Scope Revision Narrative

Austin Police Association Office Building Renovation

Addendum No.: 3

Date: 2026-07-22

ED1.1

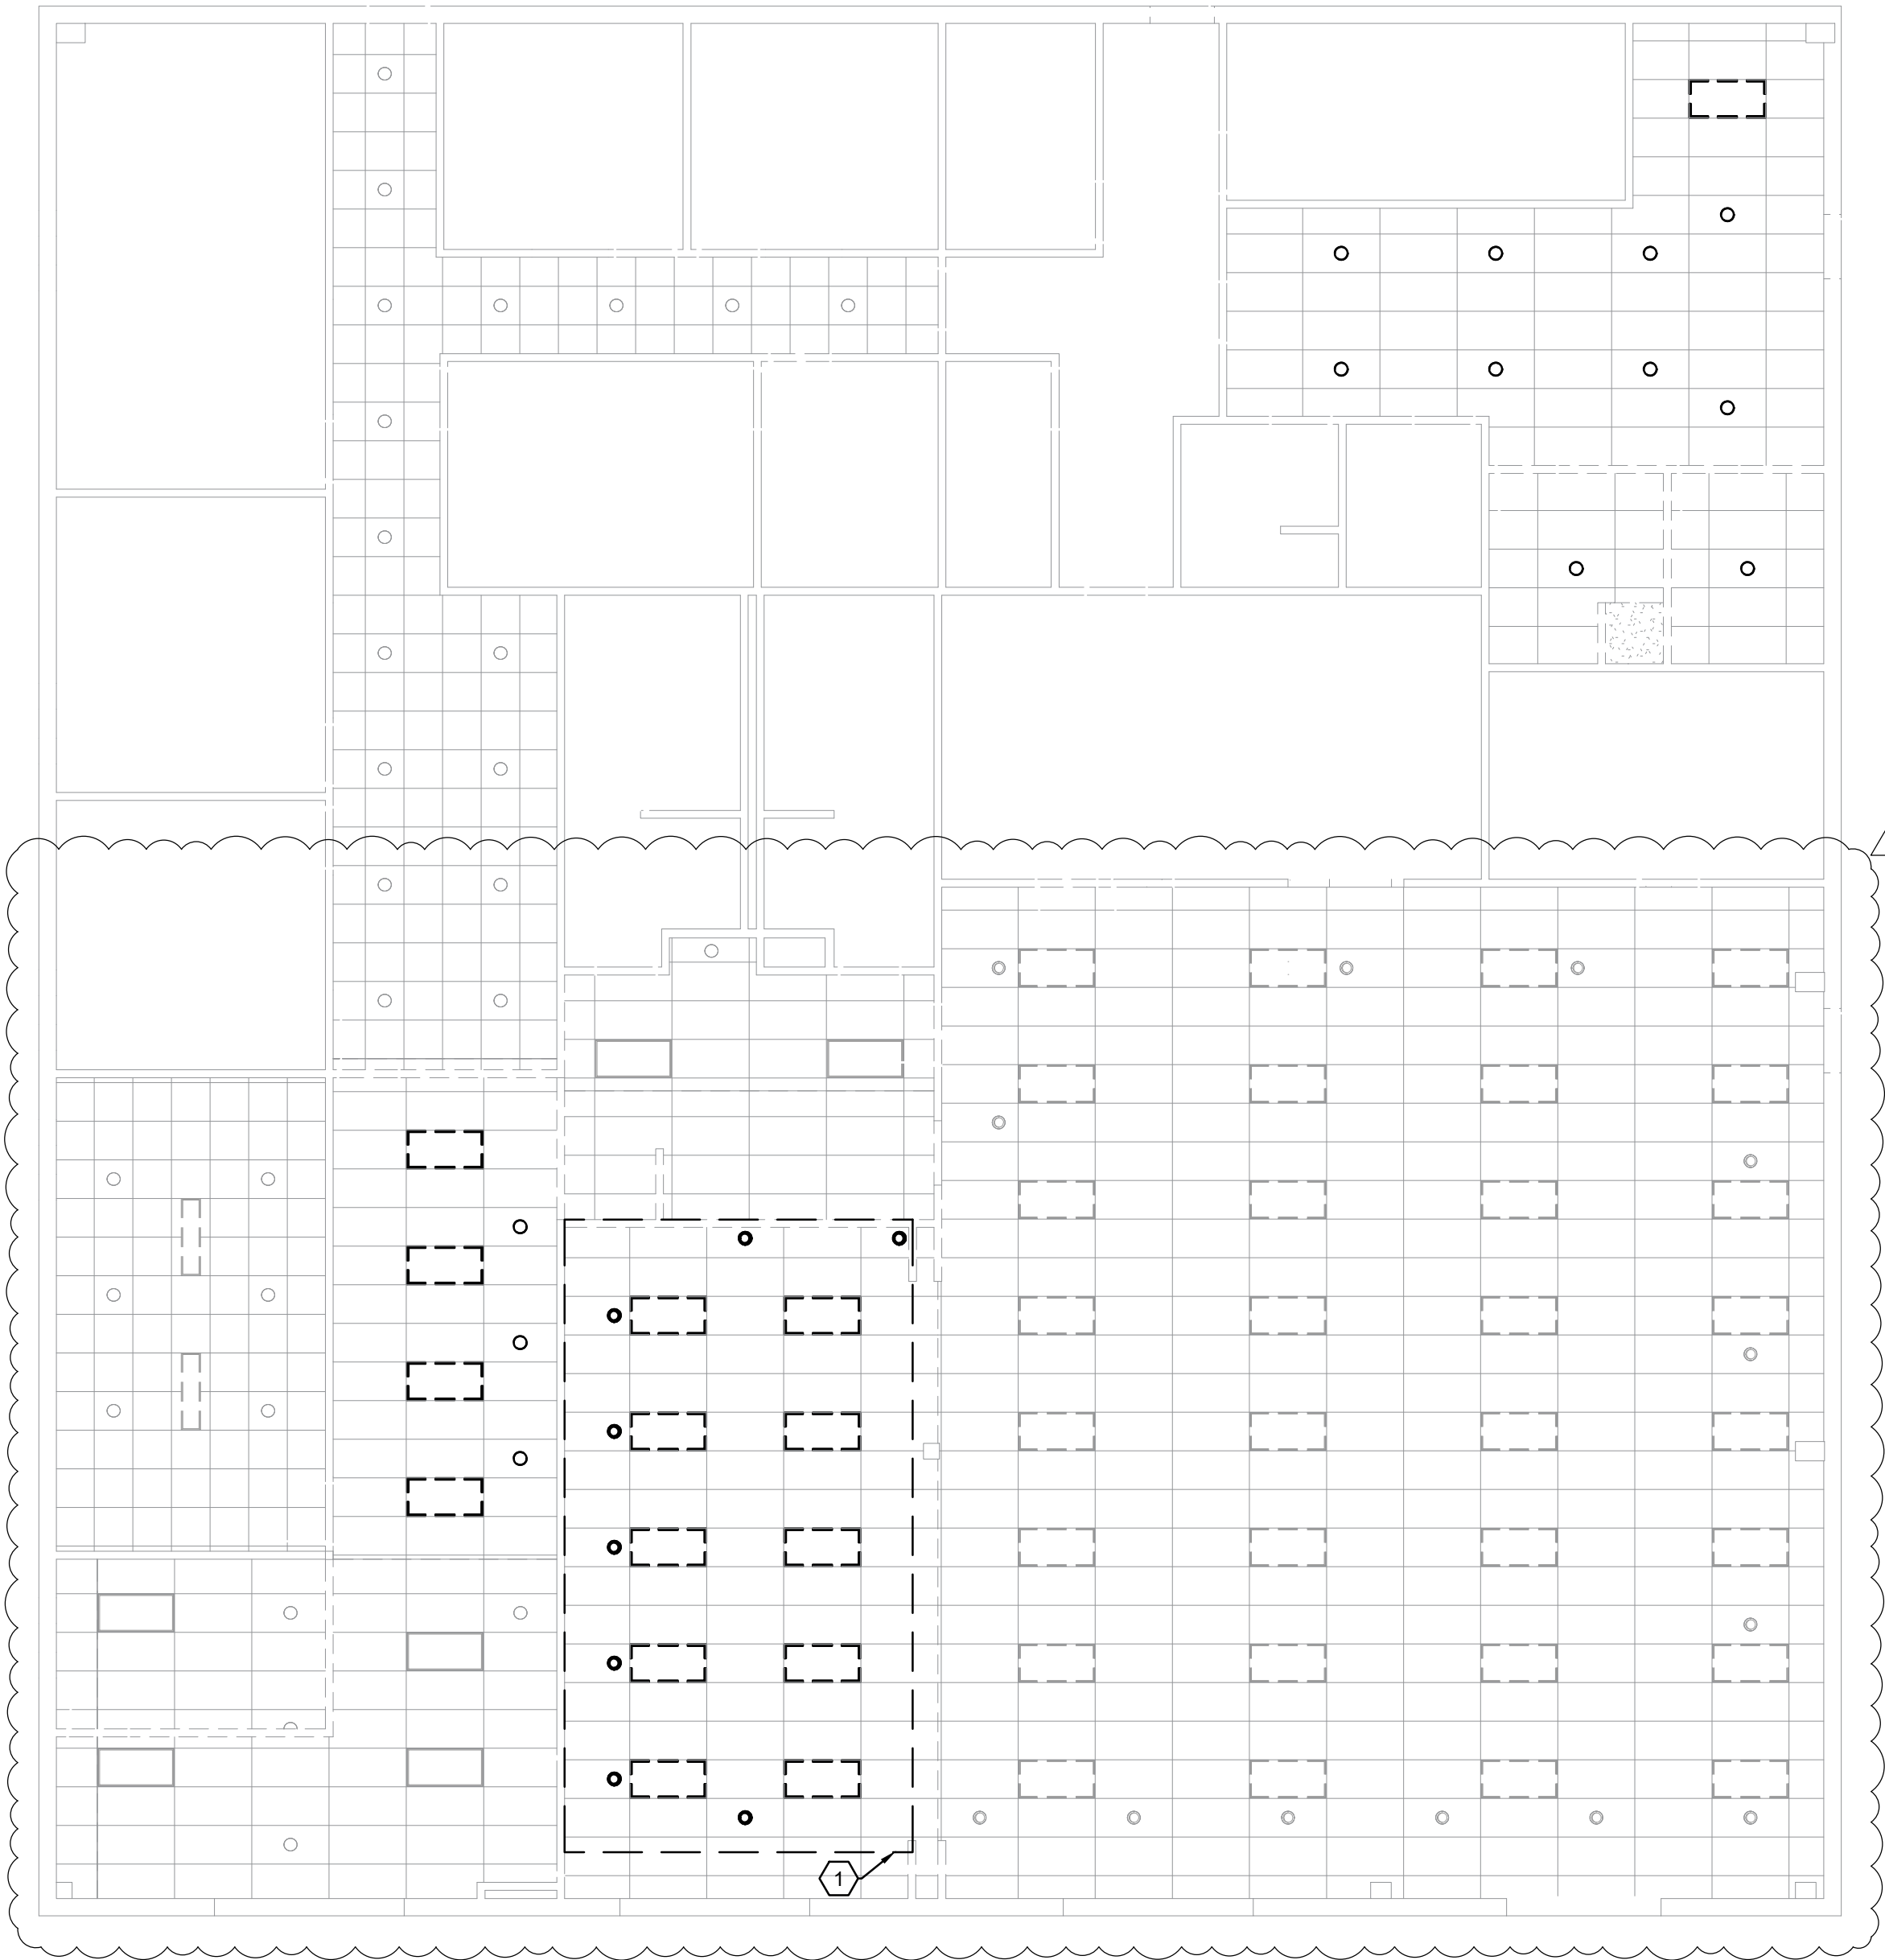
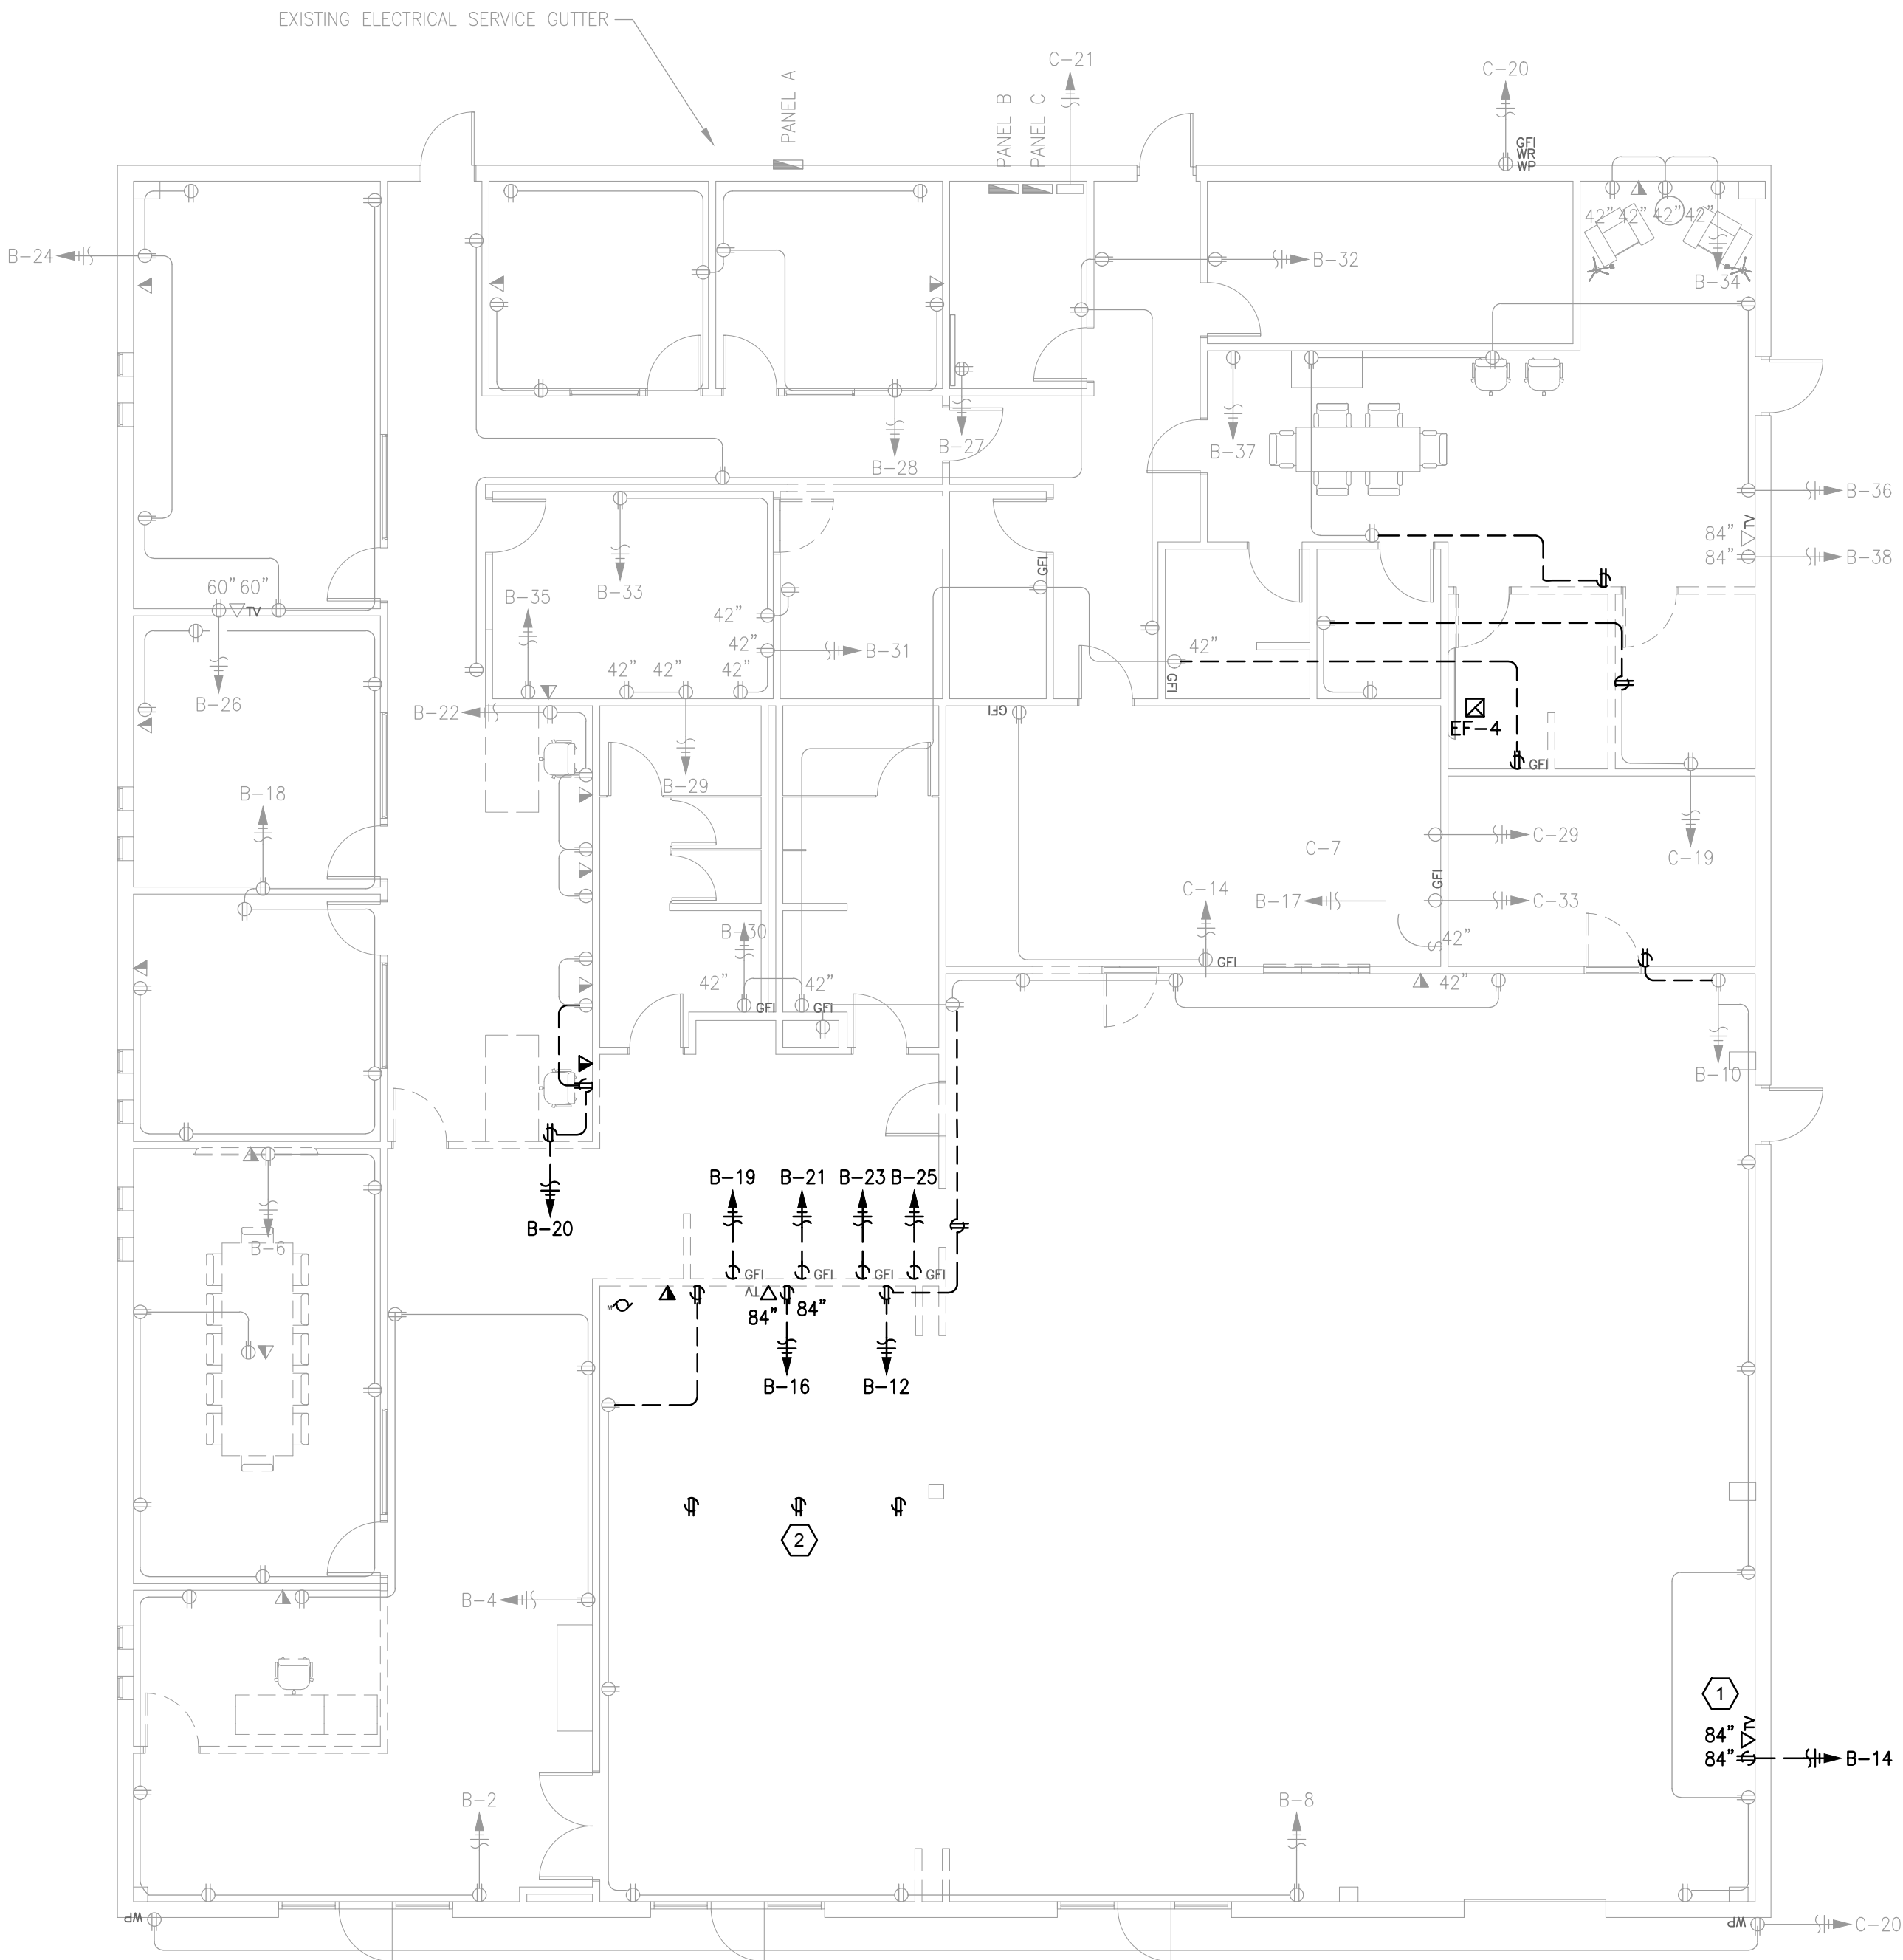
- LIGHT FIXTURES INSIDE DASHED LINE TO BE RELOCATED ON NEW CEILING GRID.

1. Delete demolition and replacement of existing lighting fixtures within the following areas:
 - Existing Training Hall / Training Room 123
 - Open Office
2. Existing light fixtures and associated components within these areas shall remain.

**1** MECHANICAL PLAN
1/8" = 1'-0"
0 4' 8' 16'

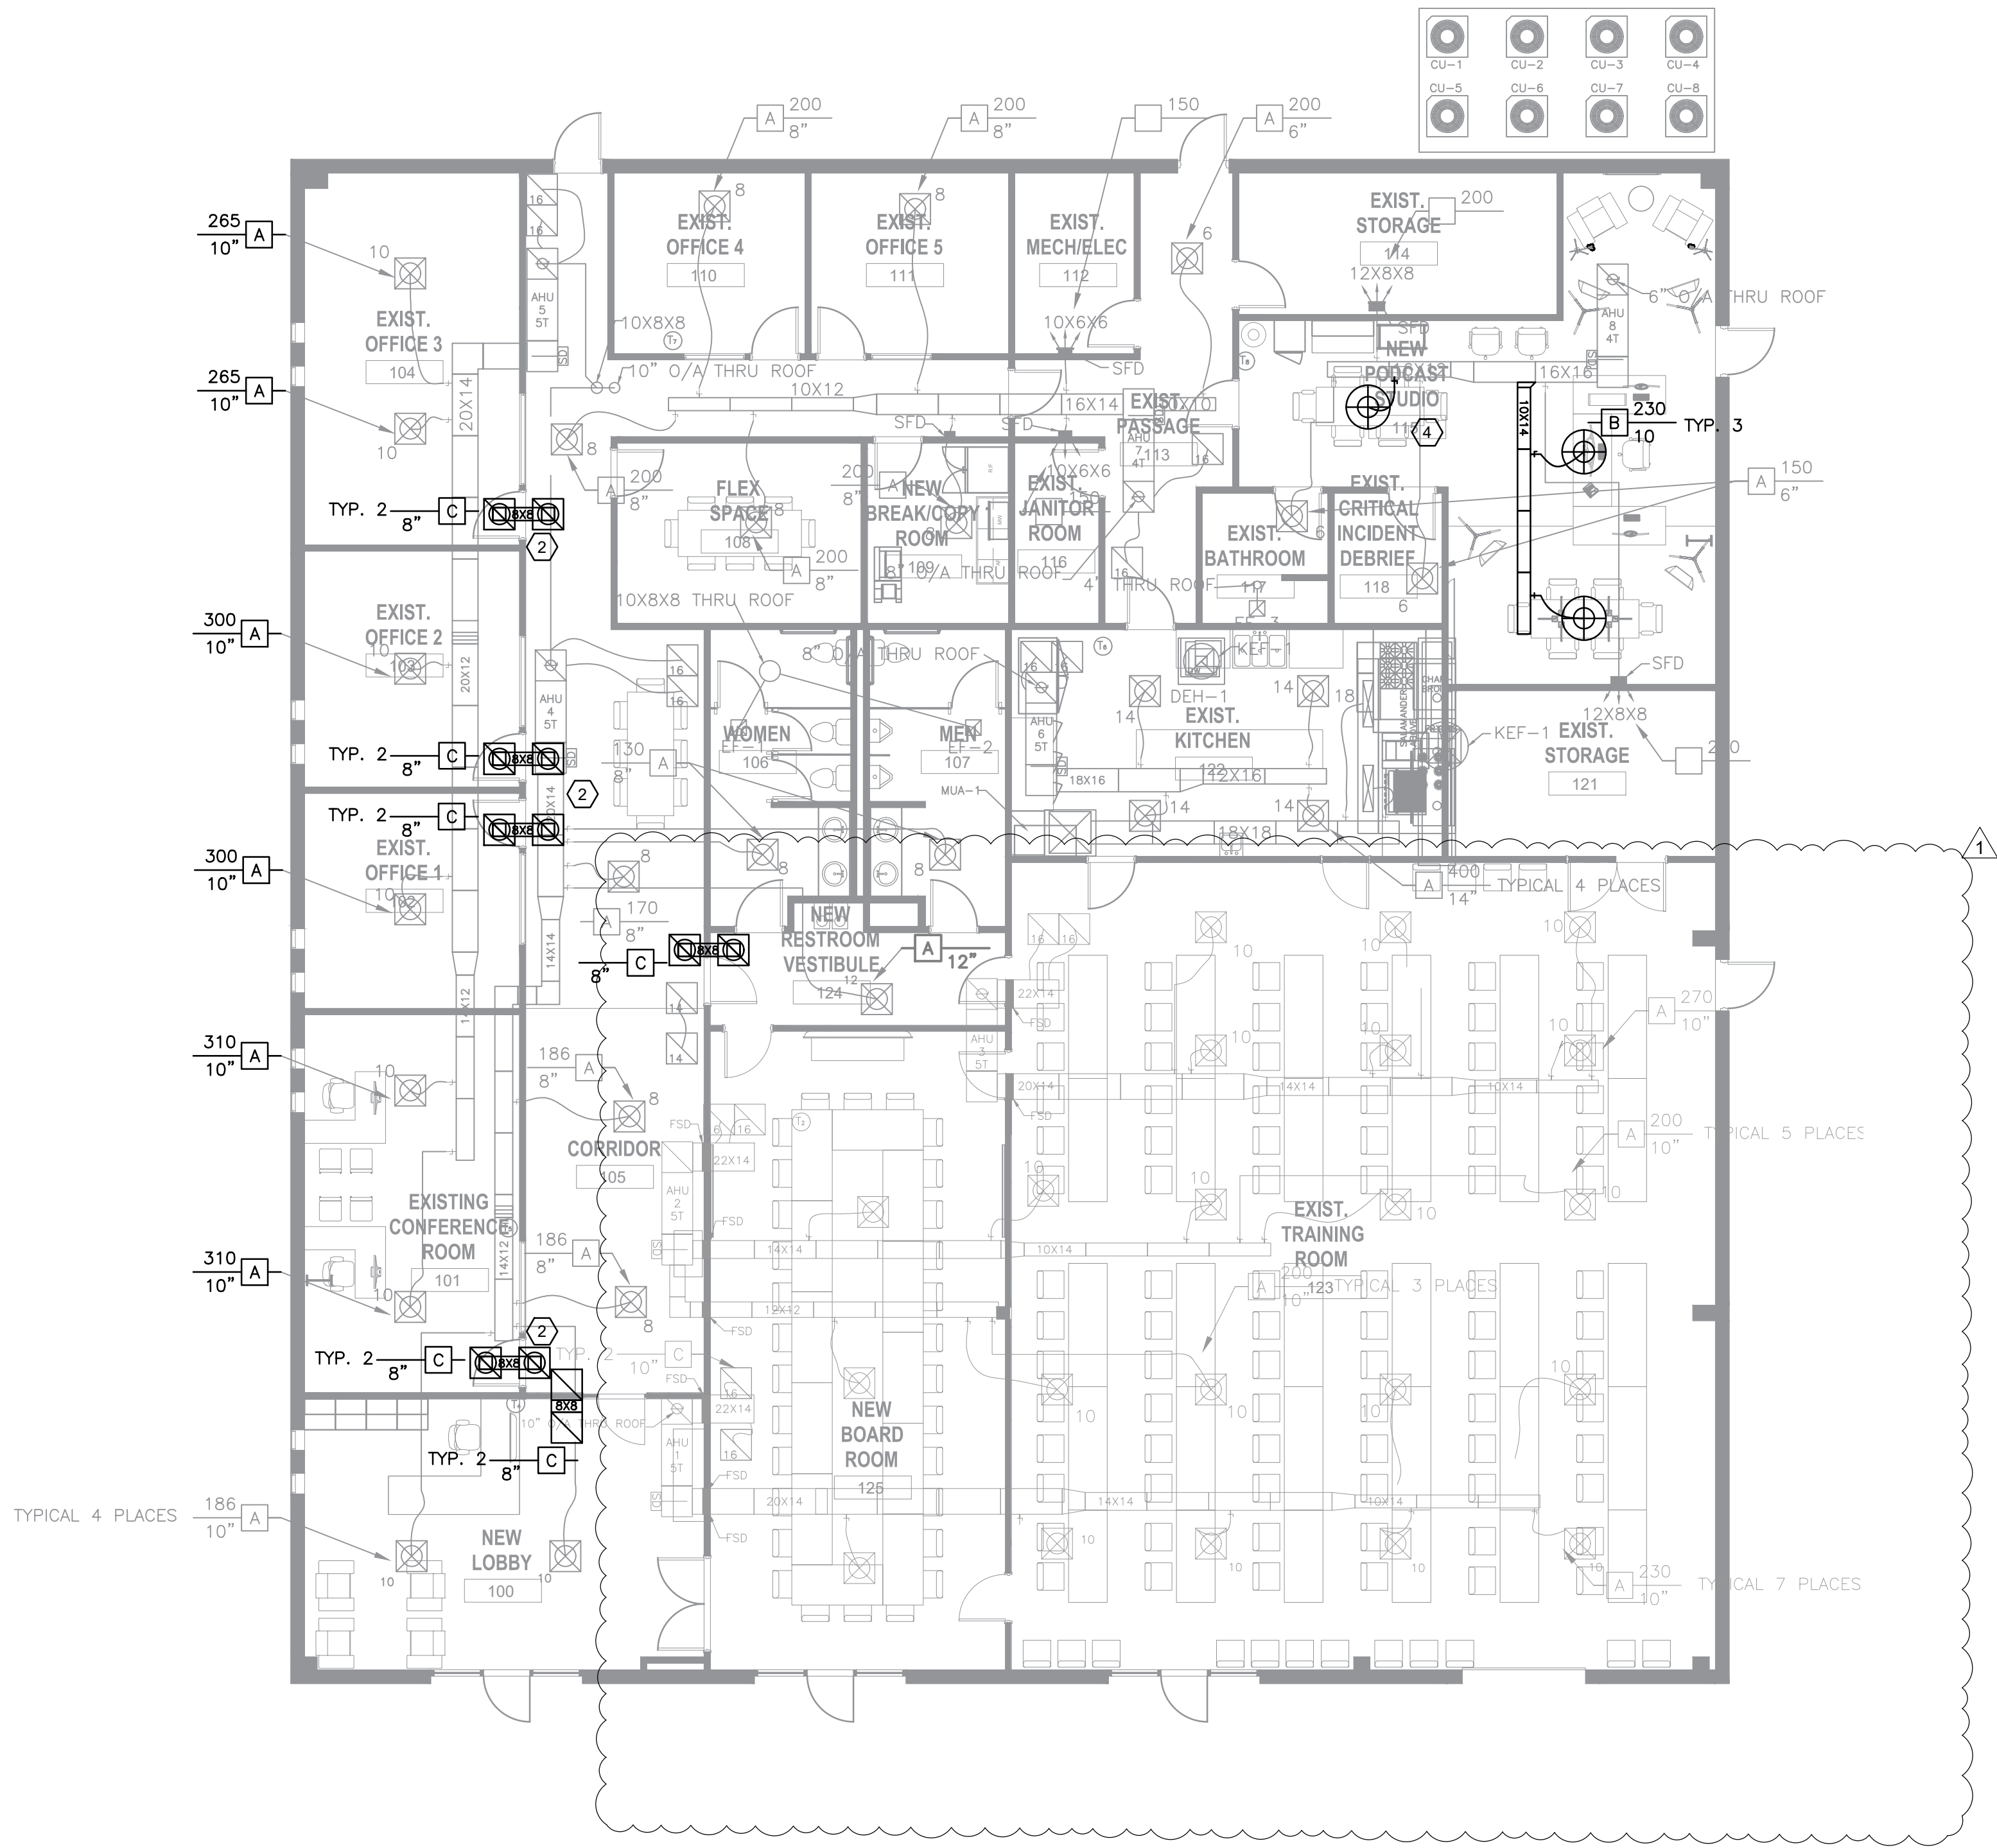
1. NOT IN USE.
2. INSTALL NEW JUMPER BOOT BETWEEN PERIMETER SPACE AND CORRIDOR. REFER TO DETAIL 1/M2.3 FOR ADDITIONAL INFORMATION.

1. Delete all HVAC demolition and proposed HVAC modifications within the following areas:
 - Existing Training Hall / Training Room 123
 - Small Training Hall / Board Room 125
2. Existing ductwork, diffusers, thermostats, controls, and related HVAC components within these areas shall remain.
3. Do not include diffuser relocations, duct modifications, thermostat replacement, control modifications, testing, balancing, or related HVAC work within these rooms unless specifically shown on the revised drawings.
